**DOCUMENT 00 90 00  
ADDENDUM**

**ADDENDUM NO. [2]                      Date: January 5, 2022**

**RE:                      SCHOOL DISTRICT OF ABBOTSFORD  
ABBOTSFORD SCHOOL DISTRICT FEMA ADDITION  
510 WEST HEMLOCK STREET  
ABBOTSFORD, WISCONSIN 54405  
HSR PROJECT NO. 21027**

**C1.0**

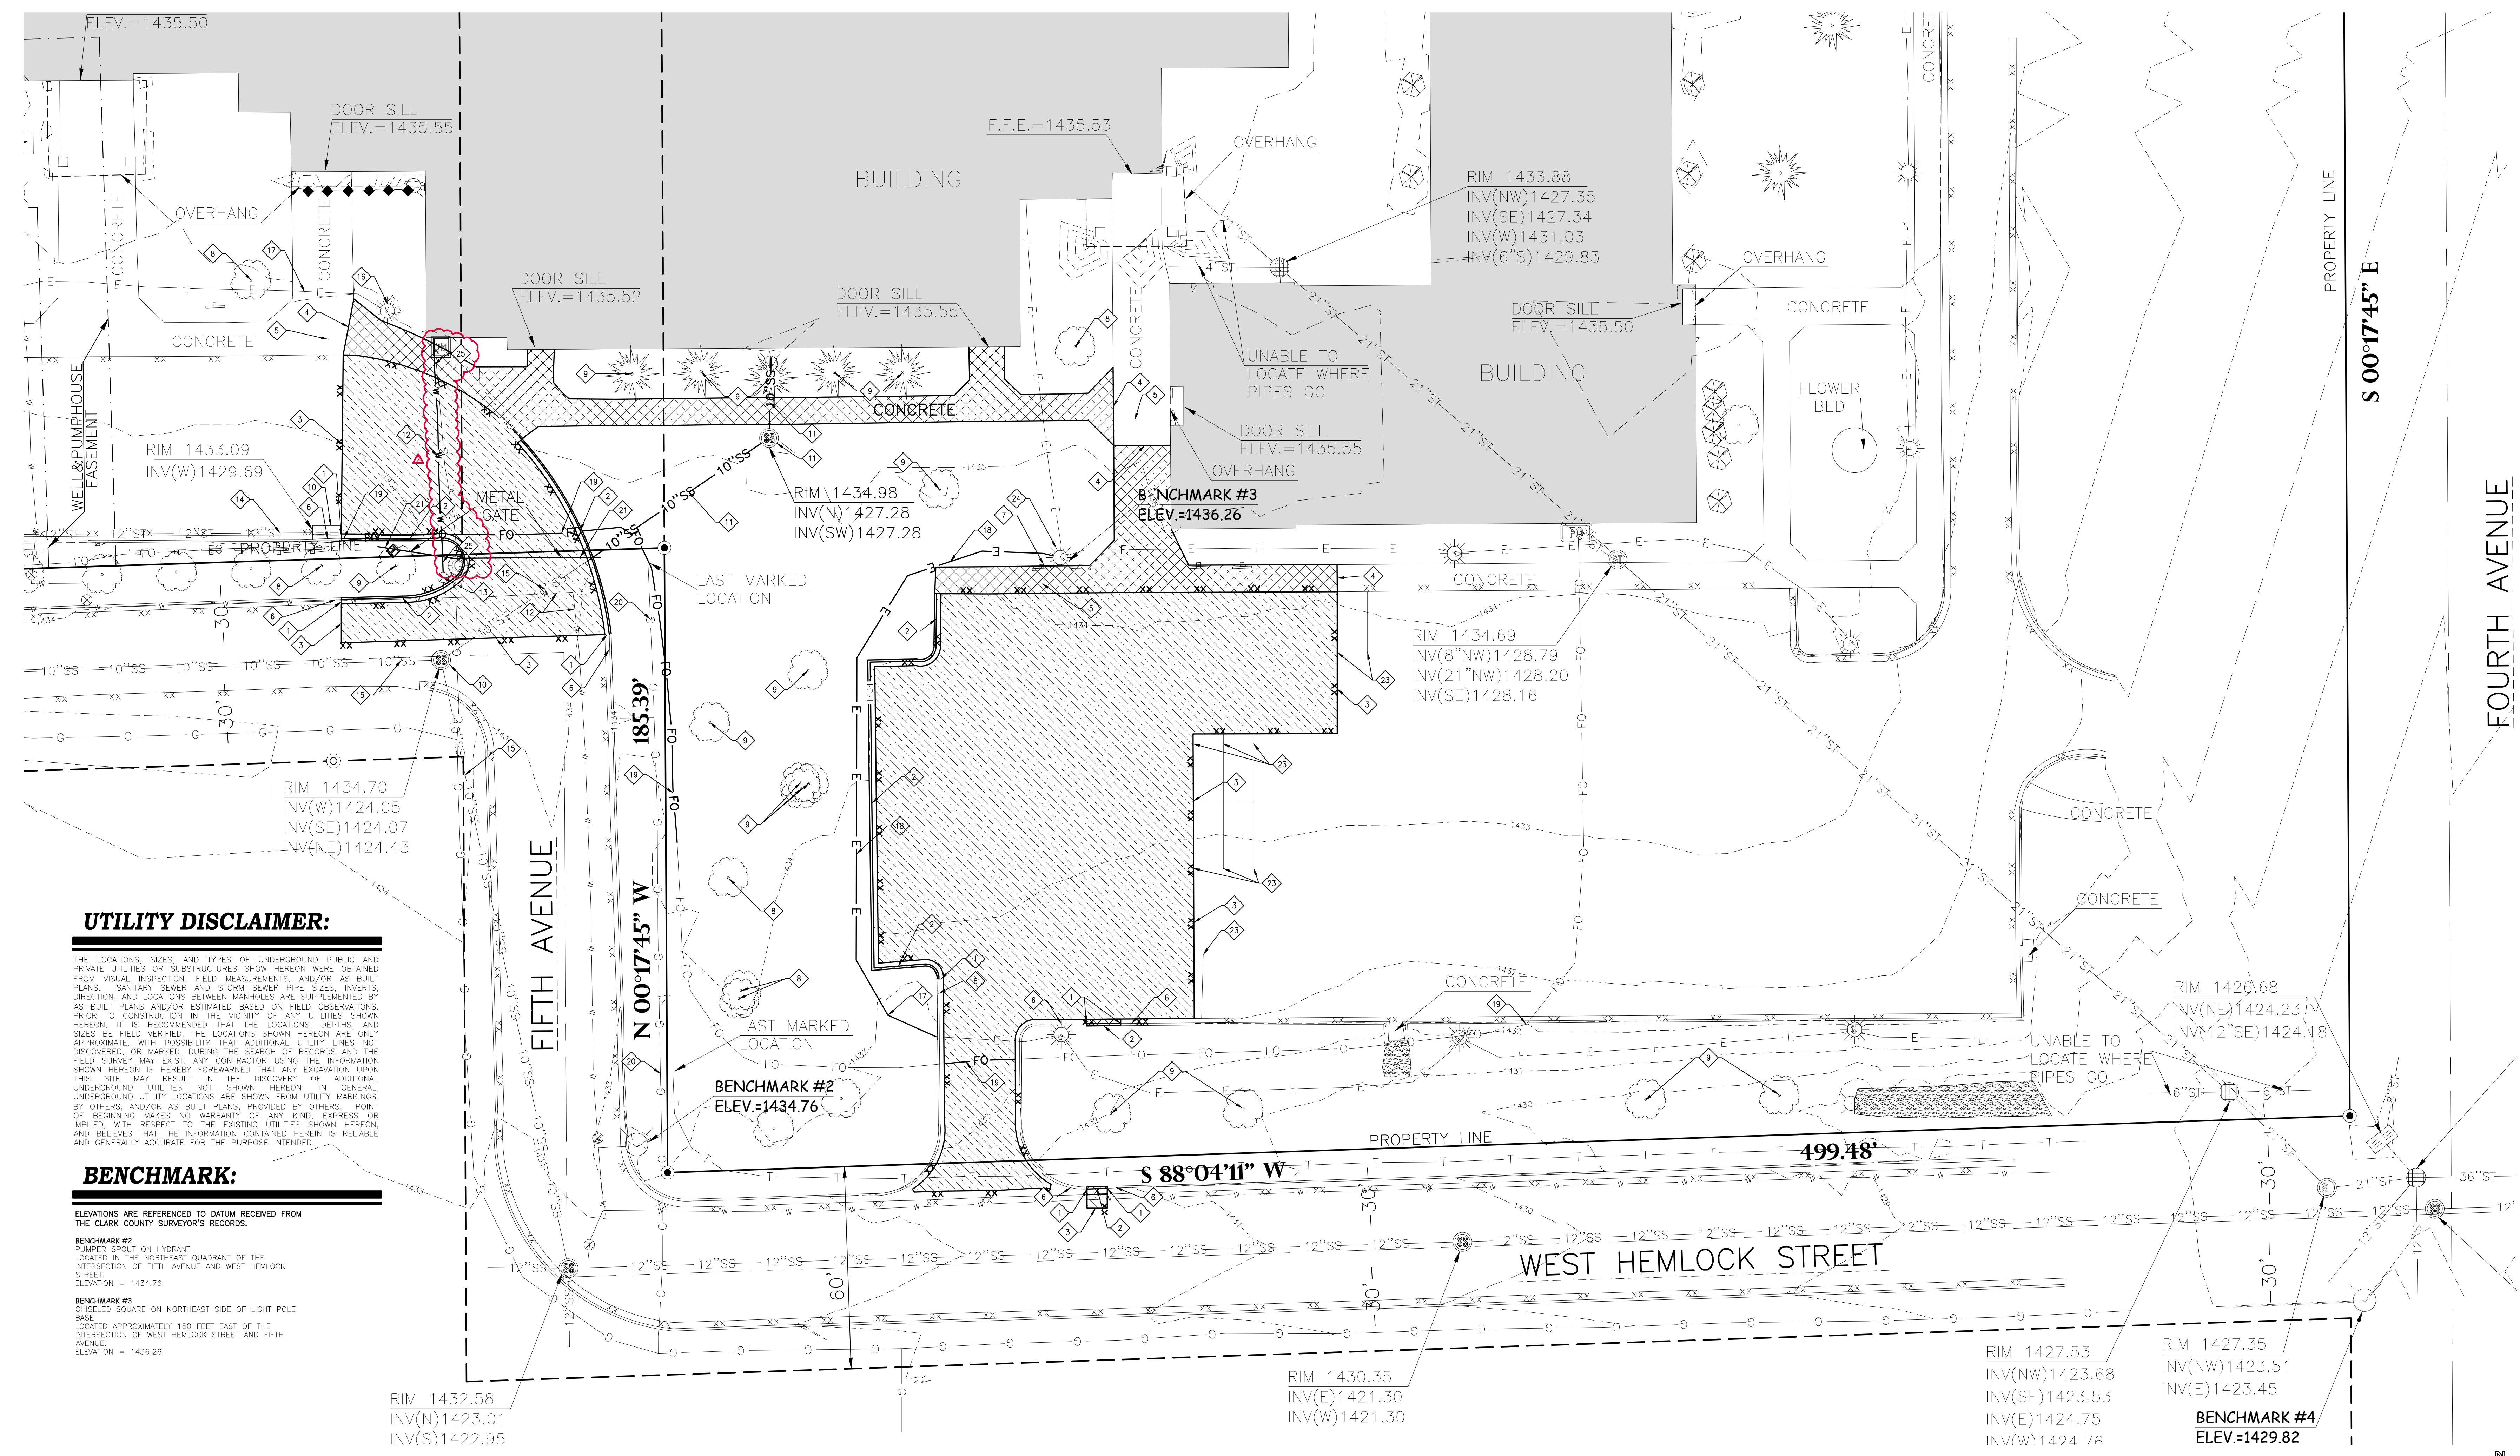
12. Sheet C1.0 DEMOLITION PLAN revised 30 x 42 sheet attached hereto.

- a. Revised key notes 11 & 25.
- b. See clouded changes on plan.

5  
C6.1

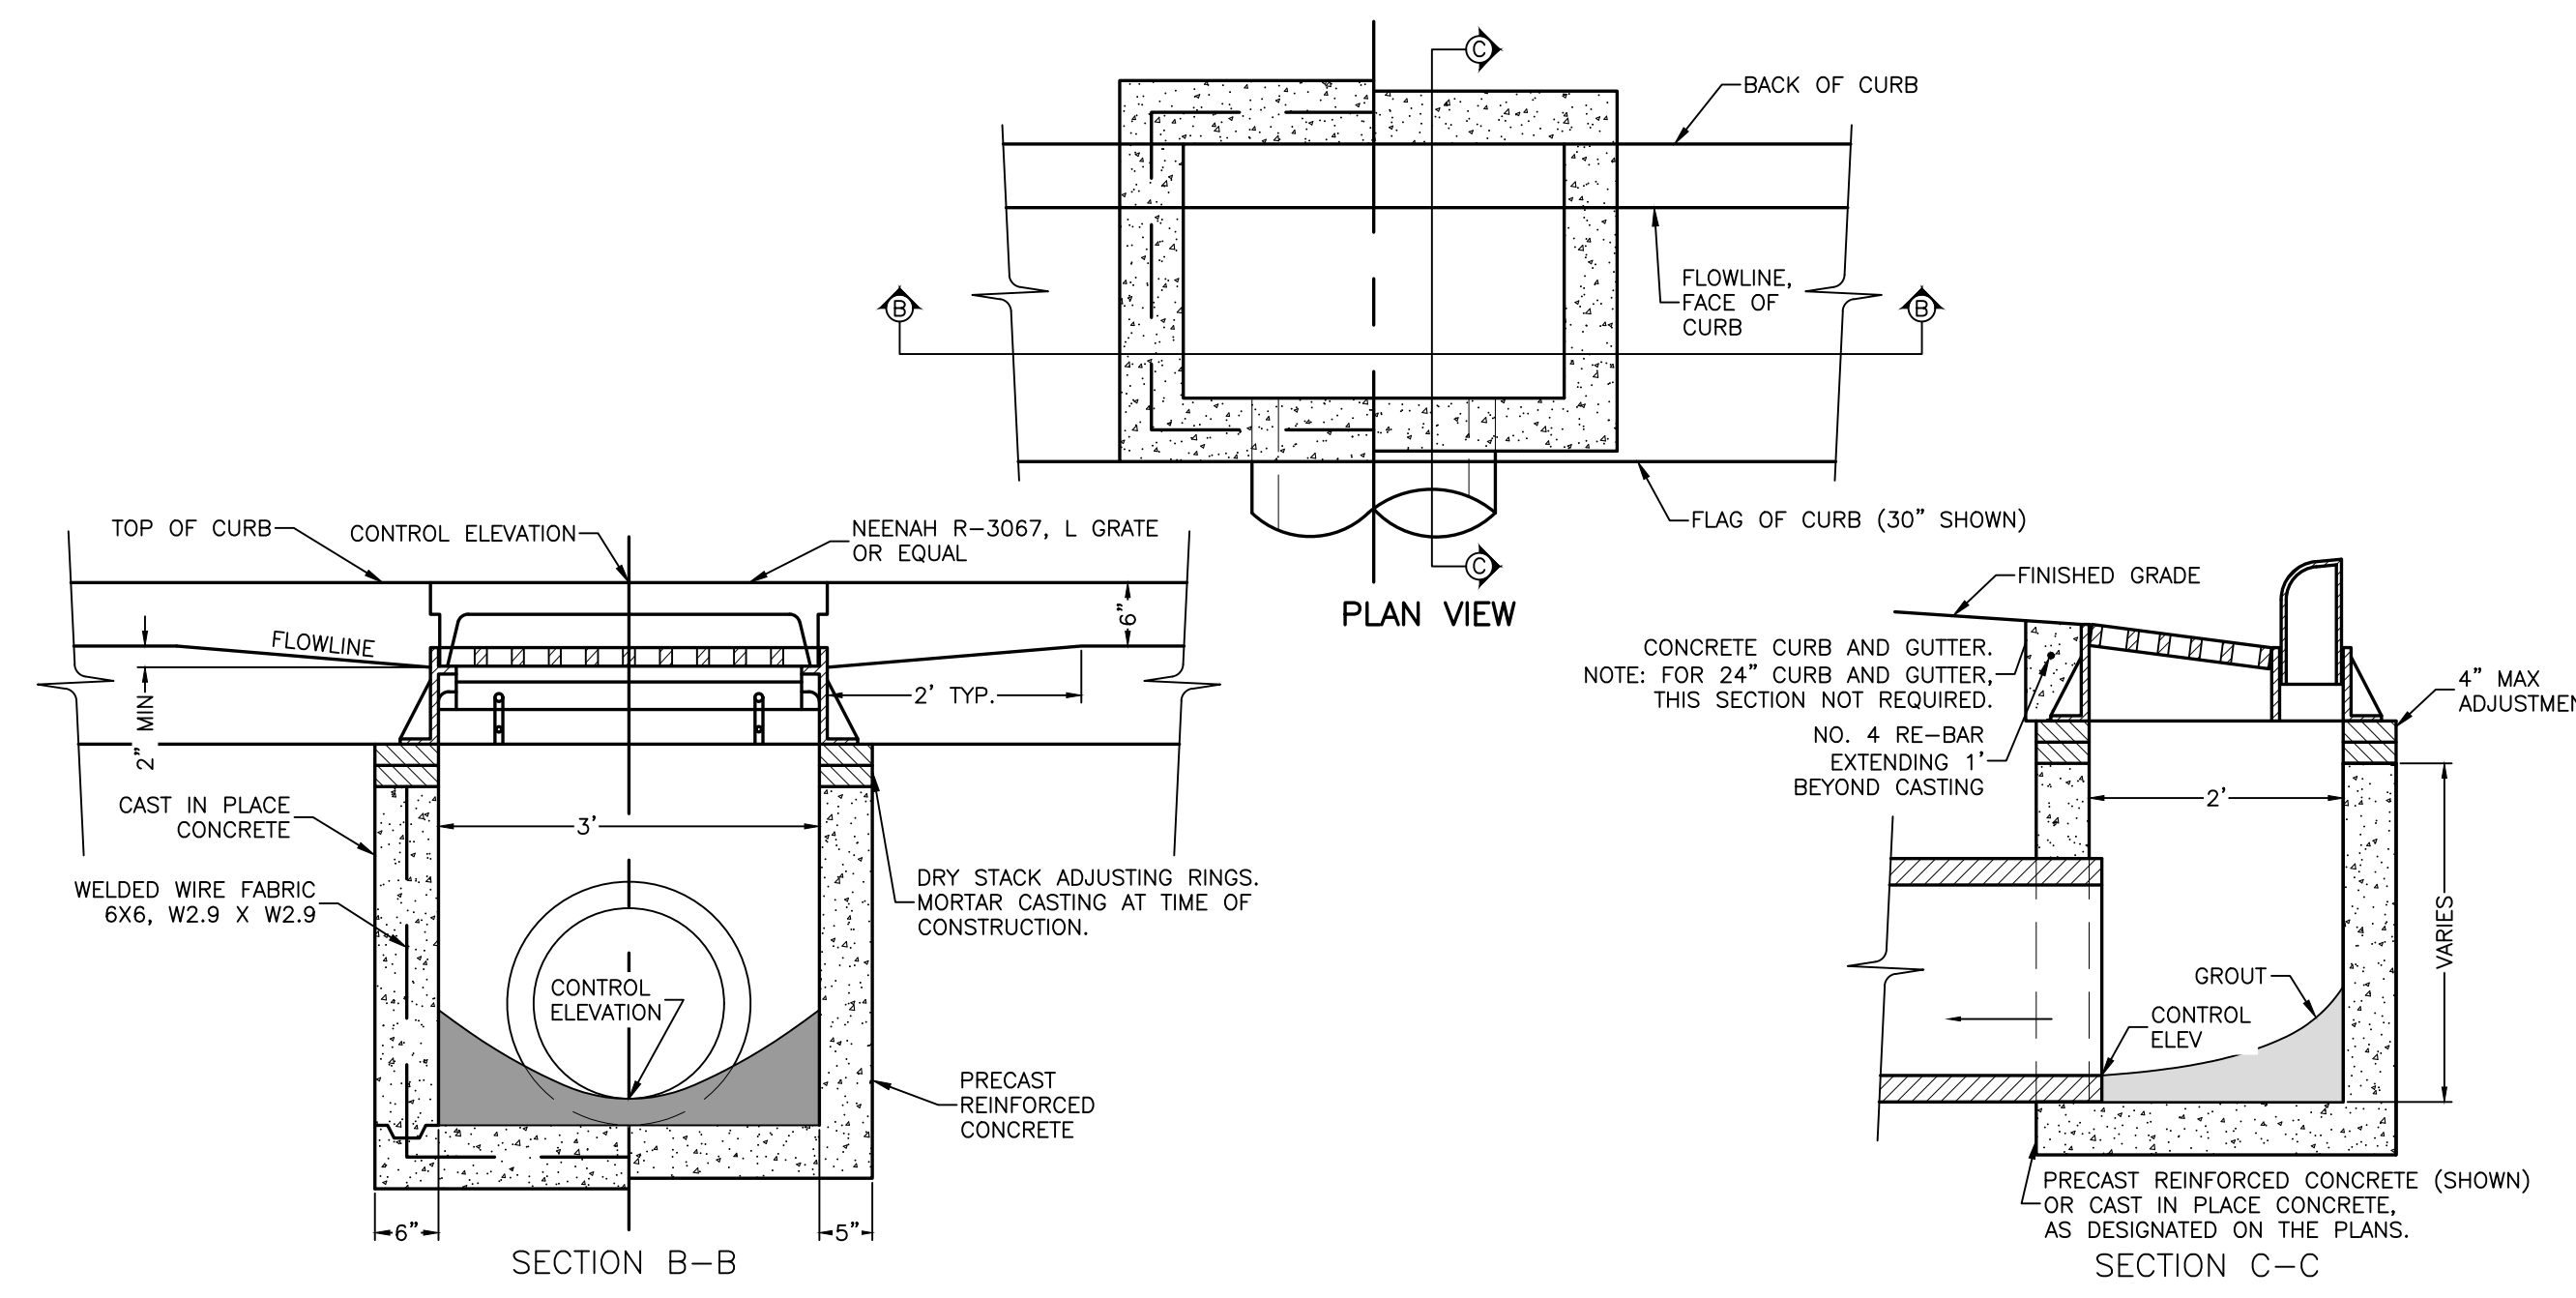
13. Sheet C6.1 DEMOLITION PLAN revised 30 x 42 sheet attached hereto.

- a. See clouded note regarding bollard cover.

**1 FIRST FLOOR PLAN**  
1/8" = 1'-0"

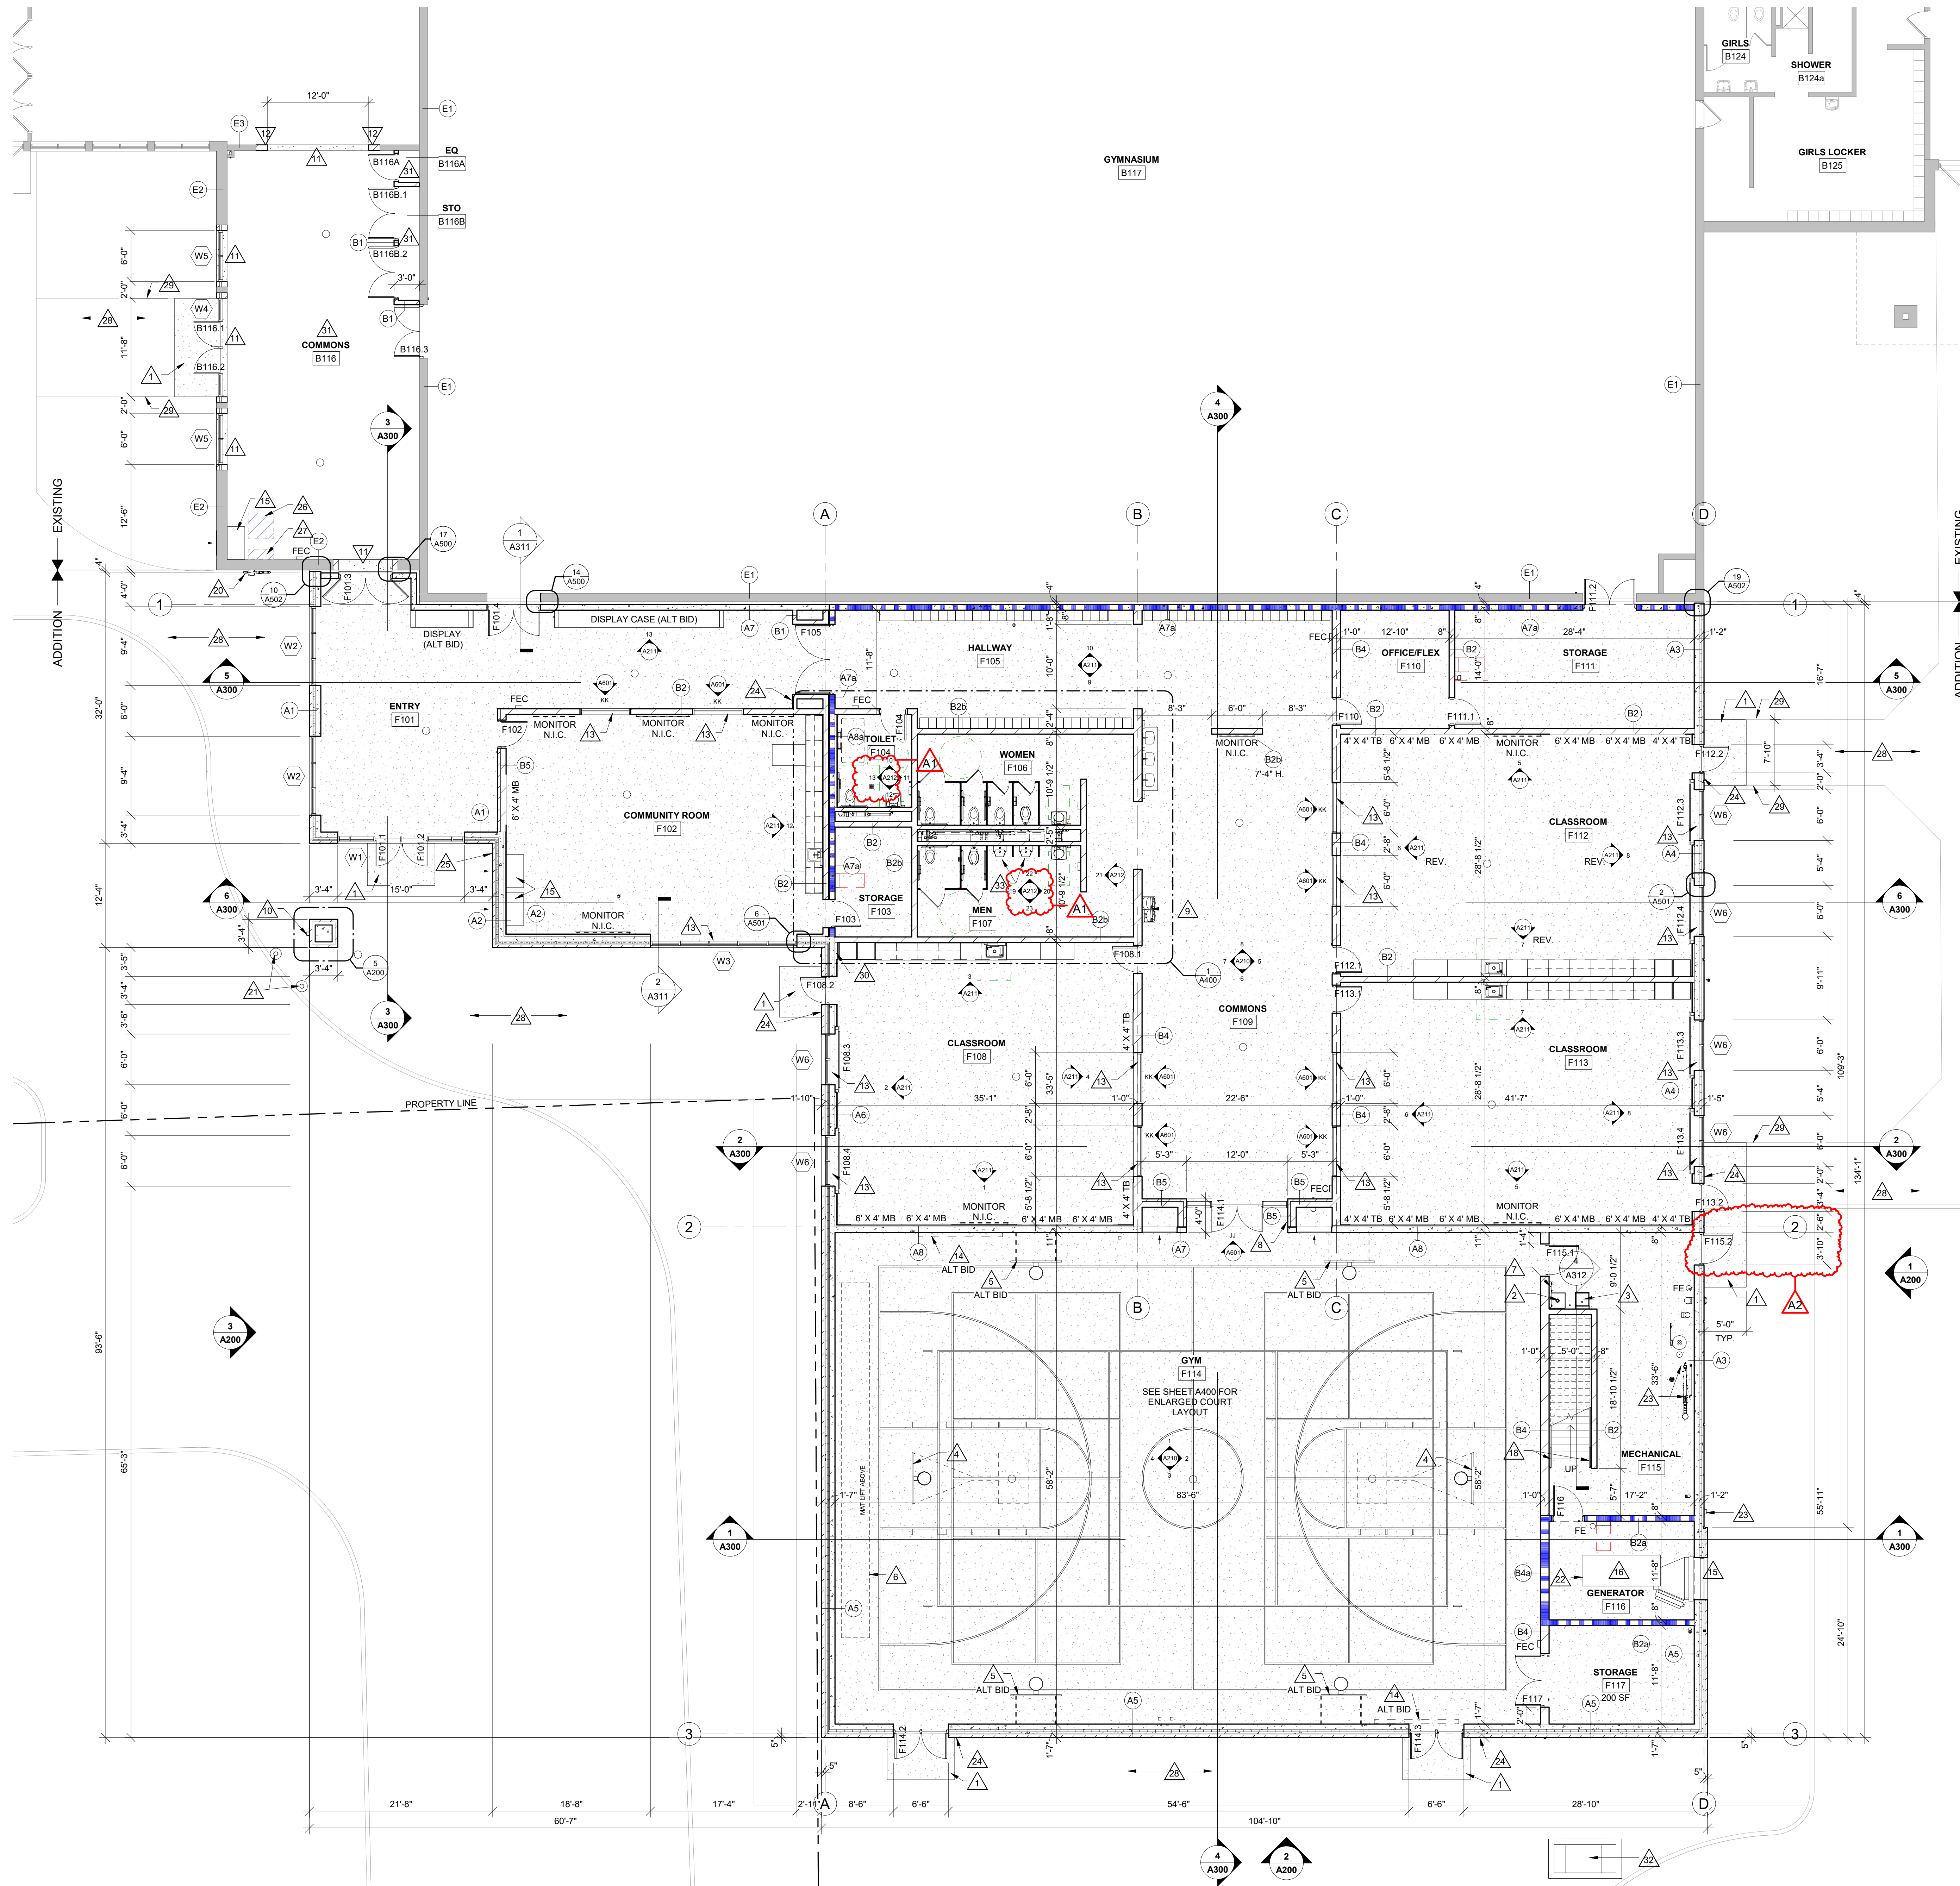
14. Sheet A101 FLOOR PLANS revised 30 x 42 sheet attached hereto.

- a. Relocated door F115.2.
